July 31, 2015

Re: Response to Warning Letter
PHMSA CPF No. 5-2015-1005W

WARNING LETTER

CPF 5-2015-1005W

KB Pipeline Overview Port Westward delivery

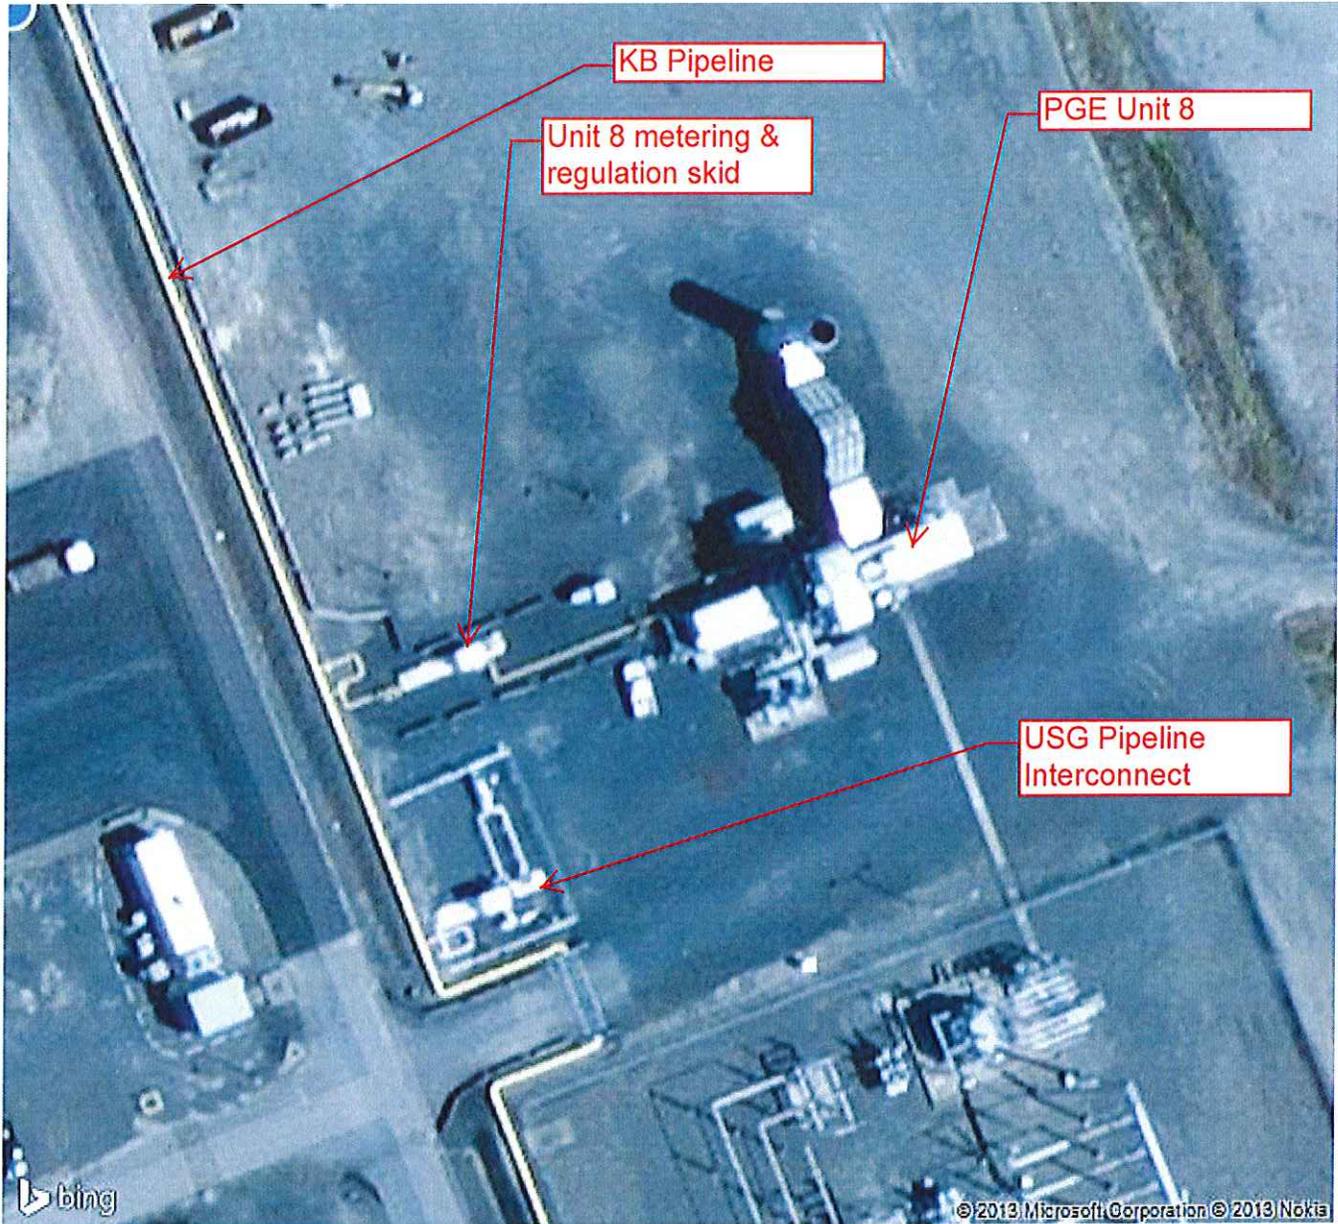
Working in the direction of KB flow, the first facility is the PGE Port Westward power plant. This facility takes full KB line pressure and also includes an onsite electrically driven booster gas compressor. This facility is designed to take full line pressure up to the gas turbine controlled regulators. This is a classic case of the fence line jurisdictional break since the OPUC has inspected the "inside the fence" facilities since initial construction. There is really nothing KB can do to overpressurize the facility, and in fact the booster compressor is evidence that KB cant supply enough pressure at times. Note that there are overpressure relief devices associated with the compressors. For clarity there is also an LDC which can supply the facility. This LDC supply is upstream of the compressors similar to KB..

I understand all that you have sent to me and so does our Oregon State Partner Michael Thompson. We are in concurrence with the attached KB Pipeline Overview.
Have a good rest of the week.

KB Pipeline Overview Unit 8 & USG deliveries

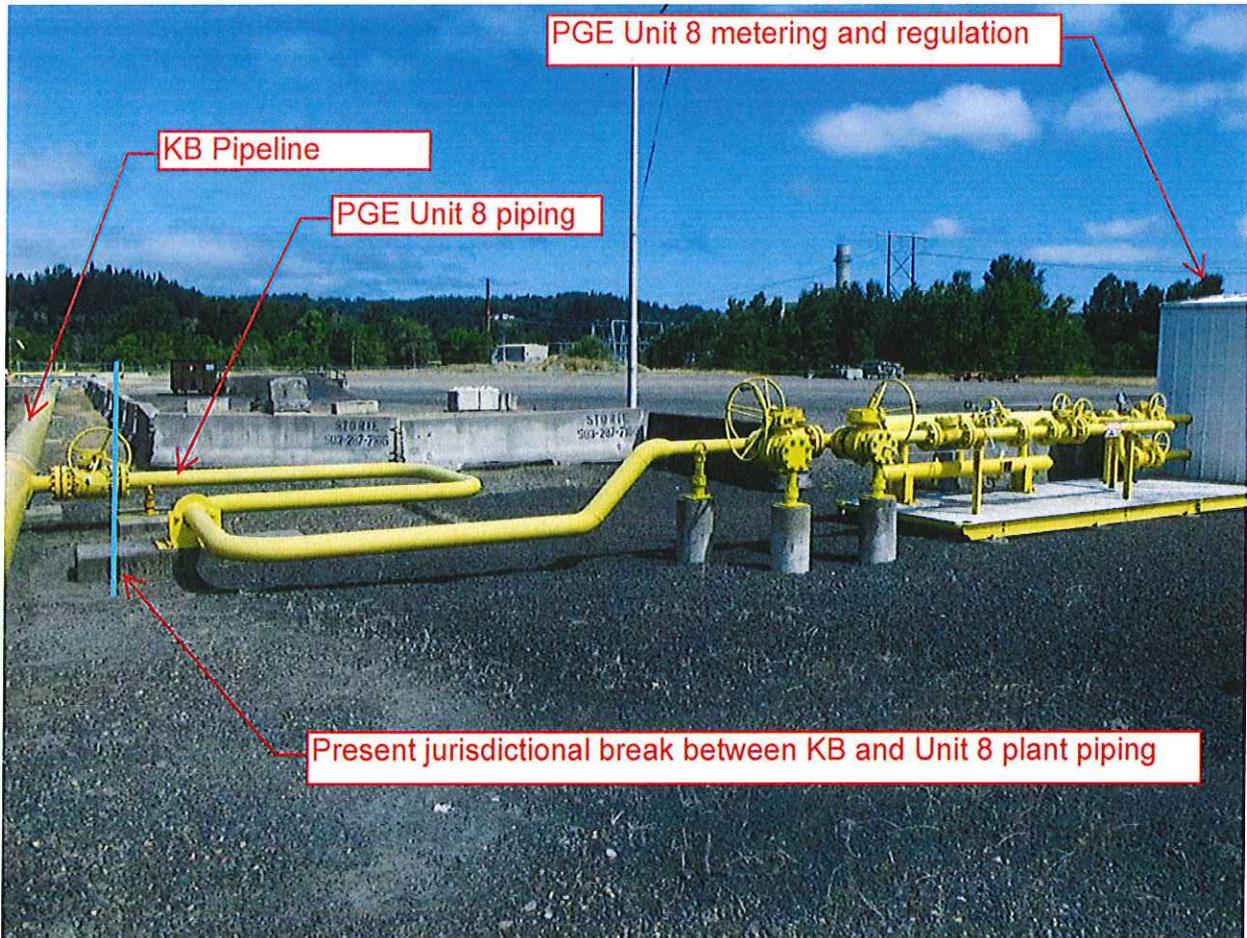
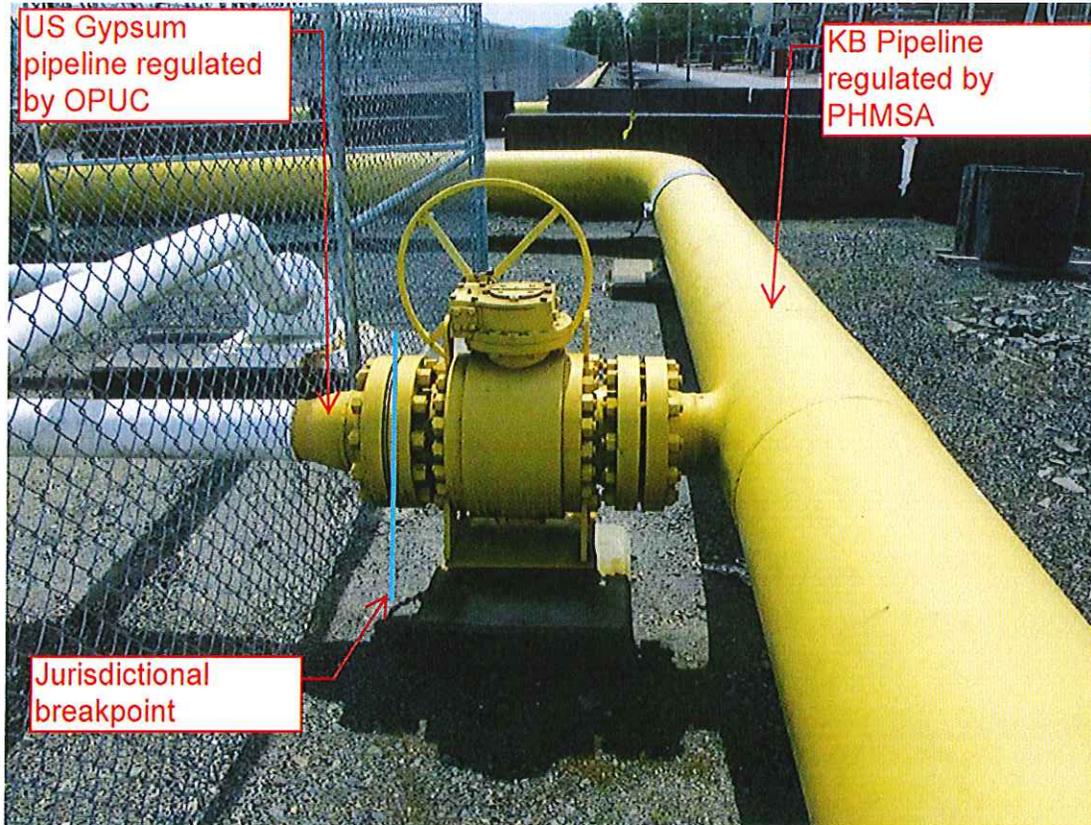
The next facility is called PGE Unit 8. As you can see, this is a stand alone gas turbine with a dedicated metering/regulation skid. Traditionally we have called the jurisdictional break the delivery valve off the KB, see photo. Downstream from that point to the monitor regulator is all above ground Class 600 piping. The regulation is a simple dual run monitor regulator feeding the gas turbine package. The equipment downstream of the KB isolation valve has been traditionally maintained by power plant personnel. It also has not been included in the facilities with oversight by the OPUC since there are no buried facilities to trigger its oversight.

The third facility is the KB to US Gypsum pipeline interconnect. The jurisdictional break has been the KB delivery valve to USG which is also at the USG fence line, see photo. All facilities downstream of the KB delivery valve are presently regulated by the OPUC as an intrastate facility.

KB Pipeline Overview Beaver delivery

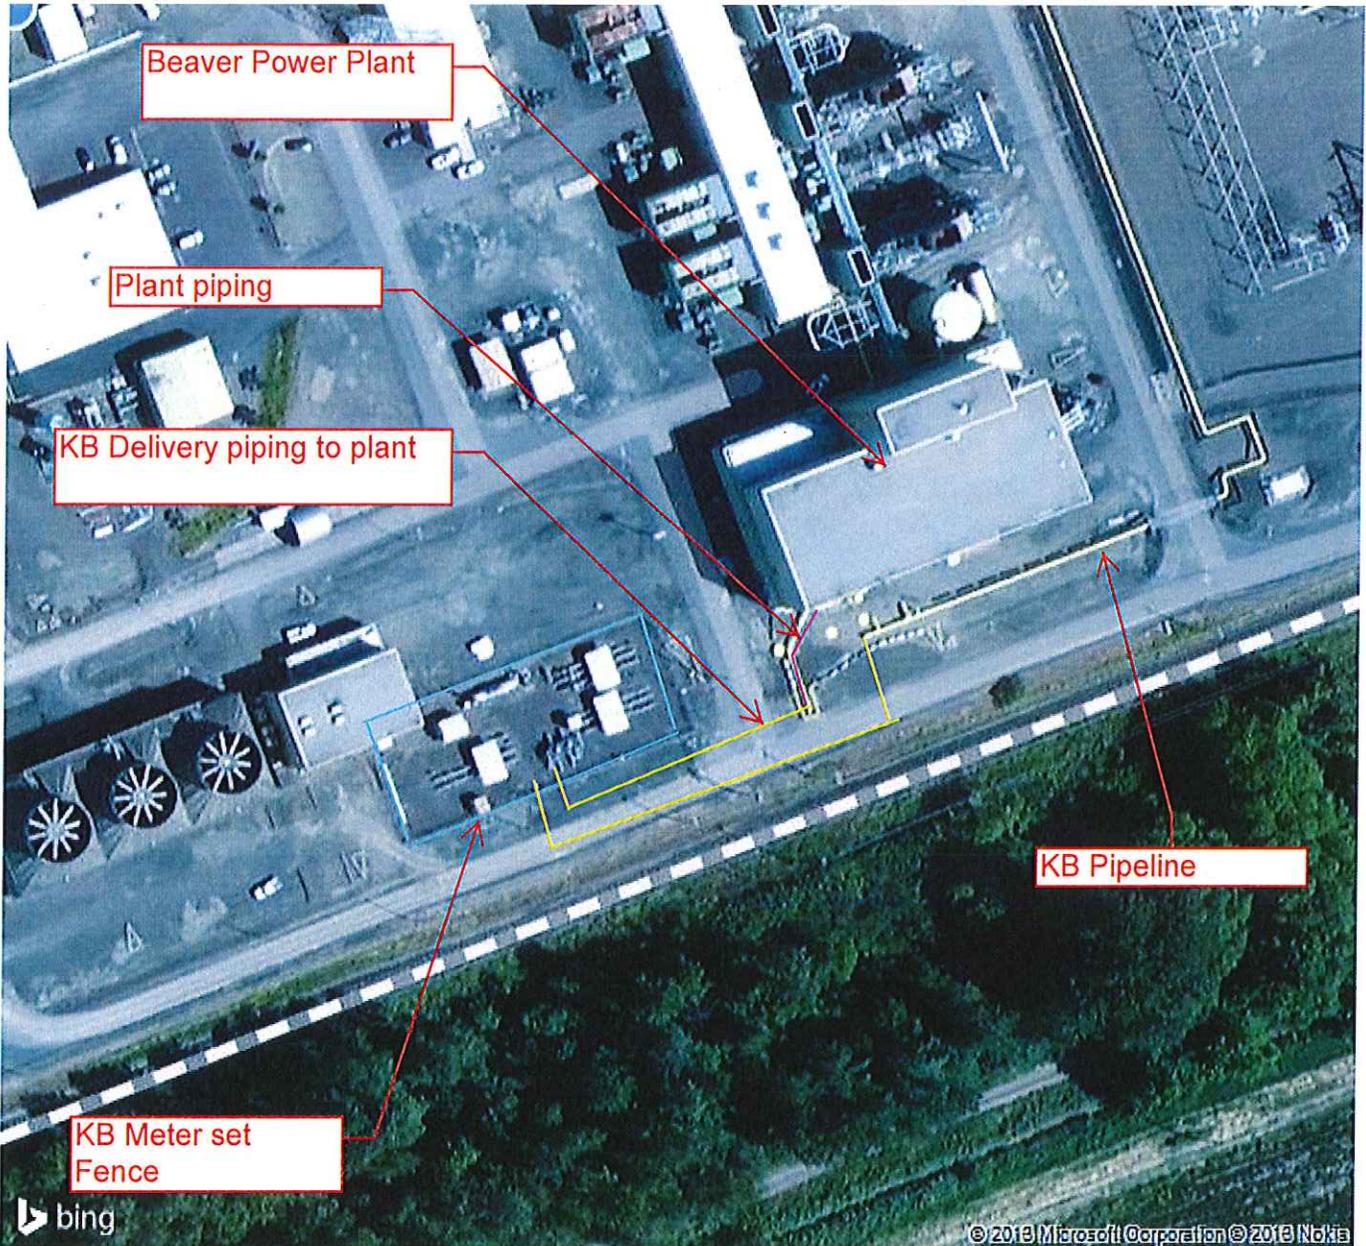
The final delivery point is the KB to PGE Beaver power plant. This delivery point has associated a traditional dual run monitor regulator arrangement and KB is responsible for all facilities up to the upstream flange of the plant owned facility isolation valve. This valve and all facilities downstream of it are operated by the plant. The delivery piping downstream of the KB meter set also is connected to the LDC. This LDC also had the ability to deliver to the plant through this same KB maintained piping. This is a traditional situation of the Pipeline company (KB) being responsible for customer overpressure protection and performing/documenting all maintenance to confirm this fact. This documentation was reviewed by Jason during the last audit and found to be satisfactory.
